<b>REFERENCE:</b>	<b>TSB:</b> 08-140-26 REV. A <b>GROUP:</b> 08 - Electrical	<b>Date:</b>	April 16, 2026	<b>REVISION:</b>	08-140-26
<b>VEHICLES AFFECTED:</b>	<b>2025 (DT) RAM 1500 Pickup</b> This bulletin applies to vehicles equipped with Proximity Approach/Departure Lamps (Sales Code LNR).			<b>MARKET APPLICABILITY:</b> <input checked="" type="checkbox"/> NA <input checked="" type="checkbox"/> MEA <input checked="" type="checkbox"/> SA <input checked="" type="checkbox"/> IAP <input type="checkbox"/> EE <input type="checkbox"/> CH <b>NOTE:</b> This bulletin applies to Middle East & Africa, North and South America and India & Asia Pacific markets.	
<b>CUSTOMER SYMPTOM:</b>	<b>Customer may experience one or more of the following:</b> <ul style="list-style-type: none"> <li>● <b>**Excessive Ignition Off Draw (IOD) on 12v vehicle battery if keys are left within proximity range.** (NA vehicles only).</b></li> <li>● RFHM software update fails when attempting to perform a flash.</li> <li>● Low vehicle battery.</li> <li>● Key fob is inoperable.</li> <li>● Proximity is inoperable.</li> </ul>

<b>CAUSE:</b>	RFHM software

This bulletin supersedes Technical Service Bulletin (TSB) 08-140-26, da

**Fig. 1**  
F08 MOD Cluster Fuse Location

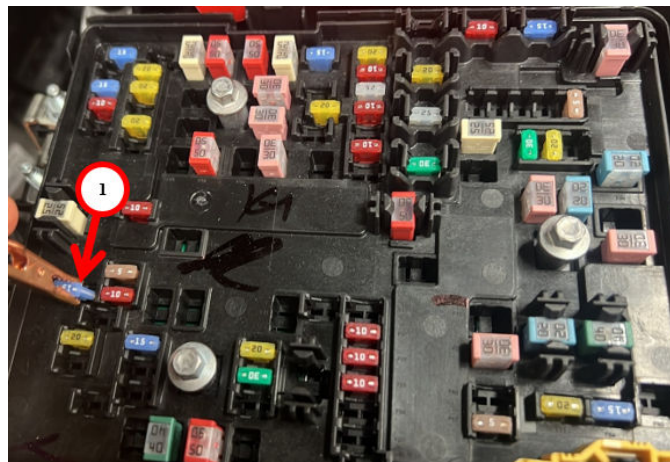
6. **\*\*Reinstall fuse F08 MOD CLUSTER from the underhood PDC [Fig. 1](#).\*\***
7. Clear all DTCs that may have been set in any module due to reprogramming. The wiTECH application will automatically present all DTCs after the flash and allow them to be cleared.
